MITIGATED NEGATIVE DECLARATION COMMENTS, RESPONSES, & REVISION ERRATA

**HARRY RENFREE FIELD RENOVATIONS PROJECT
AT DEL PASO REGIONAL PARK**

CITY OF SACRAMENTO, CALIFORNIA

NOVEMBER 2023

Figure 4: Proposed Site Plan.

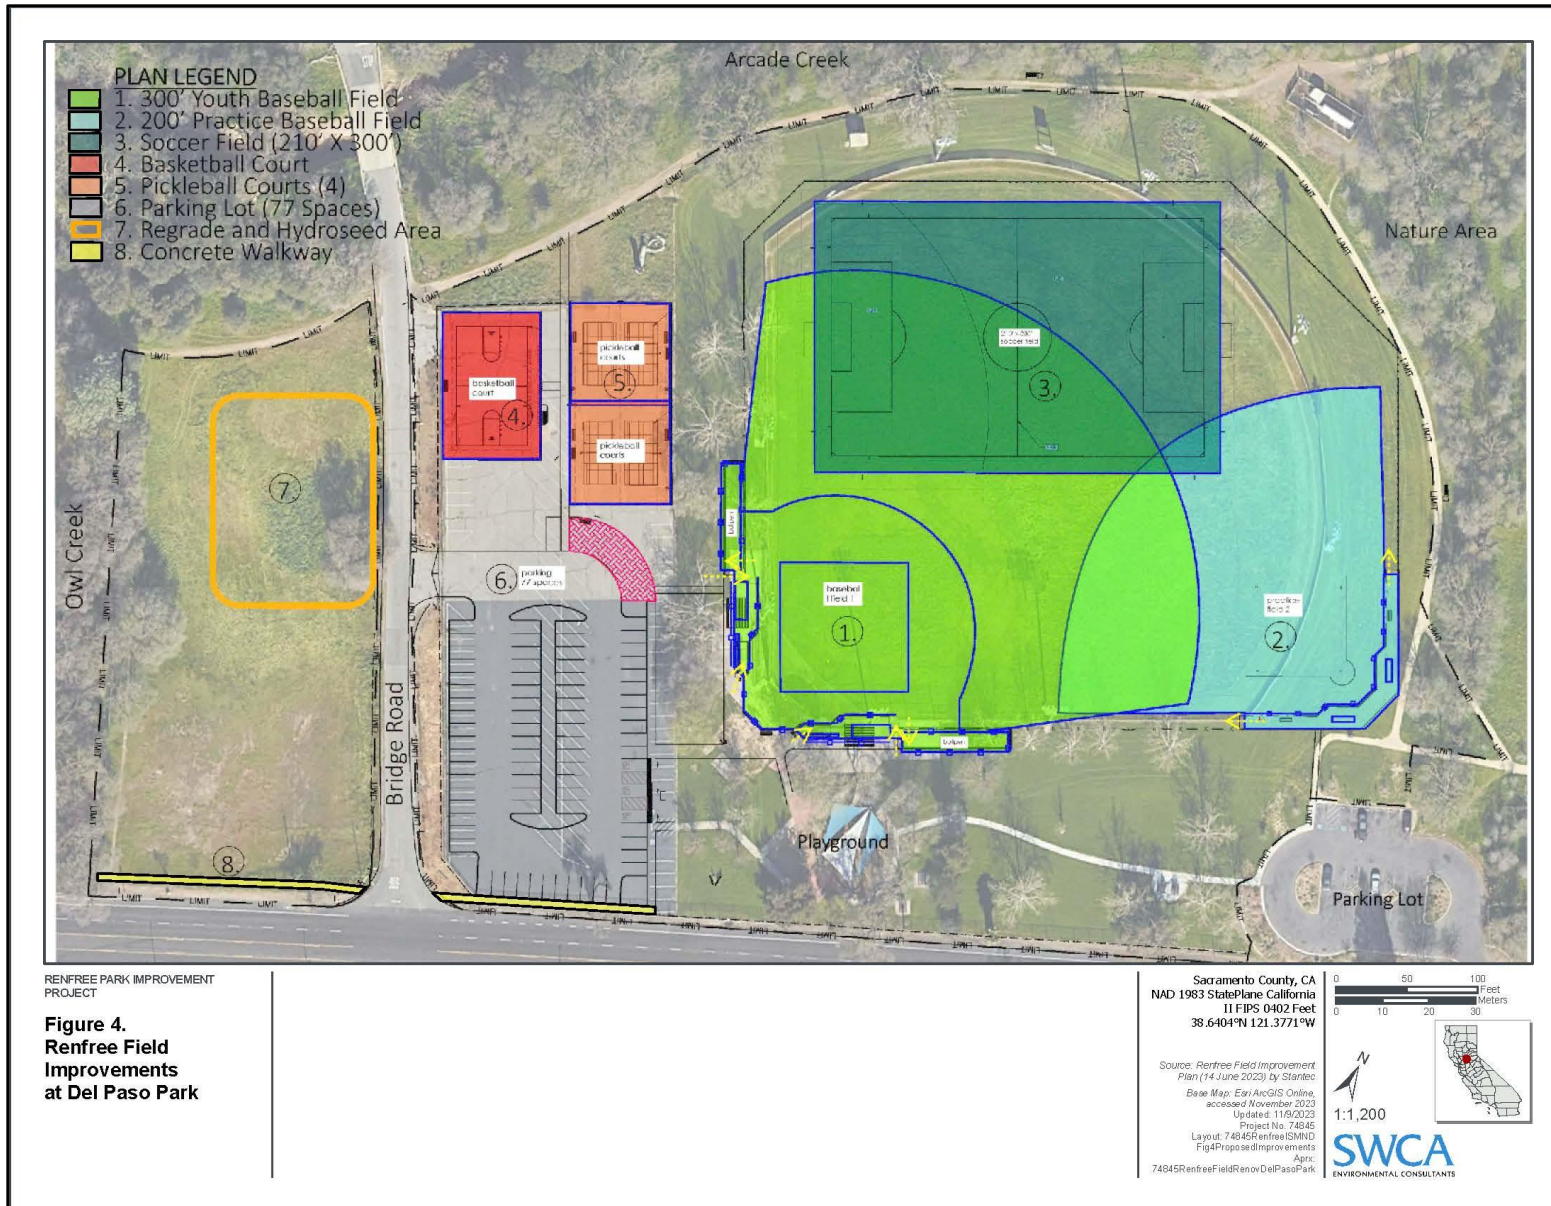
COMMENT: Sidewalk improvements along Bridge Road and on the northern side of Auburn Boulevard should be depicted in Figure 4. Renfree Field Improvements at DeI Paso Park at page 10 of the IS/MND for the Renfree Renovation Project.

TV-11	<p>The comment notes that sidewalk improvements along Auburn Boulevard are proposed as part of the project. The comment requests that Figure 4, Proposed Site Plan is updated to depict these improvements.</p> <p>The IS/MND has been updated to reflect this project component. Figure revisions have been included in the errata below under <i>Section II – Project Description</i>. This comment is noted and has been provided to City decision-makers for consideration.</p>

In response to the Tim Vendlinski letter, comment TV-11, Figure 4 has been revised to show the proposed sidewalk improvements (see Legend #8 in yellow):
